Architectural Review Board Staff Report

Project Type: Amended Architectural Elevations

Description: **Chesterfield Commons, Lot 8 (Sam's Club) Amended Architectural Elevations**: Amended Architectural Elevations and Project Narrative for a 2.171 acre tract of land zoned "PC" Planned Commercial District located on the south side of THF Blvd., between Chesterfield Commons Drive and RHL Dr.

Figure 2: Color Site Plan

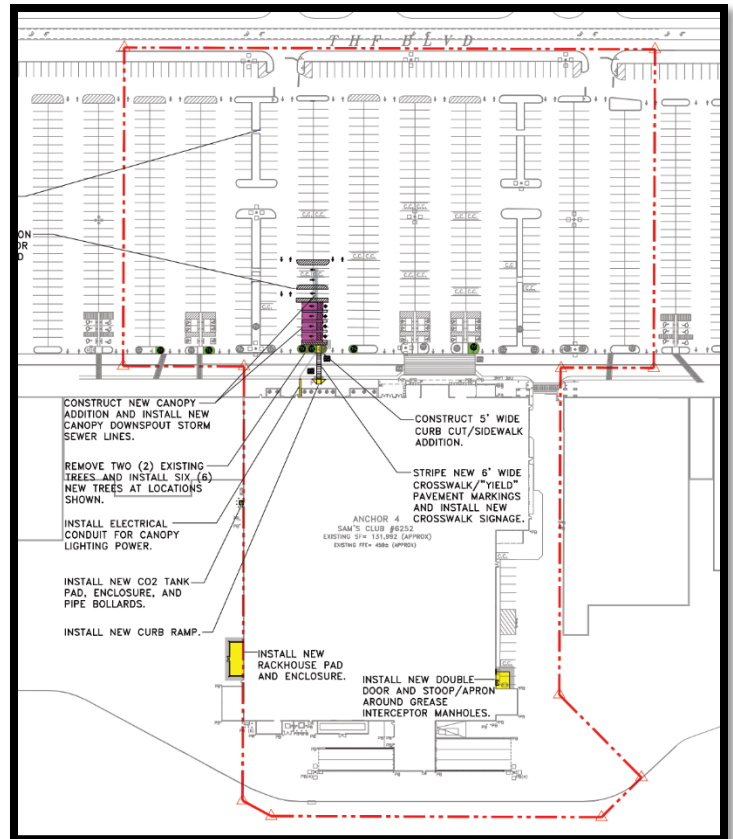
- The first addition is for an approximately 1,200 square foot canopy in the parking lot, shown in purple on the color site plan in Figure 2. The canopy will have an aluminum face. This addition allows up to four customers to pull in and have their orders delivered to their vehicle by an employee of the Sam's Club. The installation of this canopy would be located near the western front of the building and also includes a cut through a landscape island and a relocated tree. This cut through allows the employee to more directly access the rear of the customer's vehicle.

- The second addition is for a refrigeration enclosure on the west side of the building, shown in yellow on the color site plan in Figure 2. The applicant would like to utilize chain link fencing. Chain link fencing is discouraged in commercial developments. This portion of the building is visible to traffic traveling east behind the Chesterfield Commons development. It will be shielded from view from the north by additional buildings within Chesterfield Commons, from the south by chilled produce storage, and from the east by Sam's Club itself. Additionally, there is currently chain link fencing with screening fabric located at the rear of the Sam's Club, along with several other businesses in Chesterfield Commons.
